Re: *North American Electric Reliability Corporation*

The North American Electric Reliability Corporation (“NERC”) hereby submits Notice of Filing of the North American Electric Reliability Corporation of Revisions to the Definition of “Bulk Electric System.” NERC requests, to the extent necessary, a waiver of any applicable filing requirements with respect to this filing.

**NERC FIGURE B: Example of a Radial System with Low Voltage Distribution Loop**

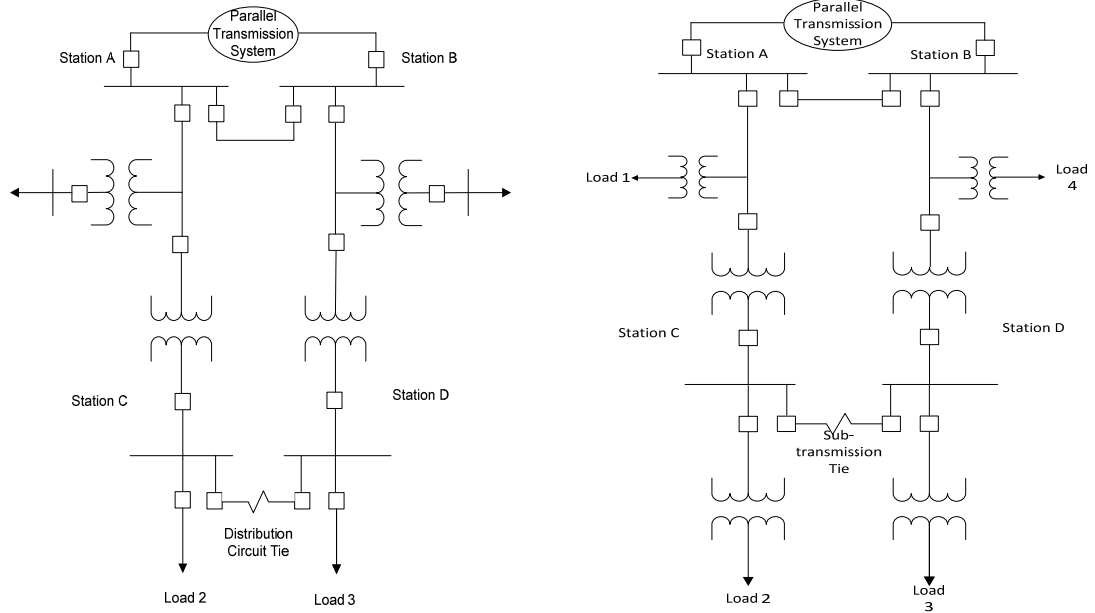
This study focused on two typical configurations: a distribution loop and a sub-transmission loop. Examples of these configurations are depicted below in Figures B and C.

The study evaluated a range of voltages for the loop and the parallel transmission system with the goal of determining the voltage level below which single Contingencies on the transmission system would not result in power flow from a low voltage distribution or sub-transmission loop to the BES. The study included sensitivity analysis varying the loads and impedances. Variations in loop and transmission system impedances account for a range of physical parameters such as conductor length, conductor type, system configuration, and proximity of the loop to the transmission system. This study provided the low voltage floor that can be used as a consideration for BES Exclusion E1.
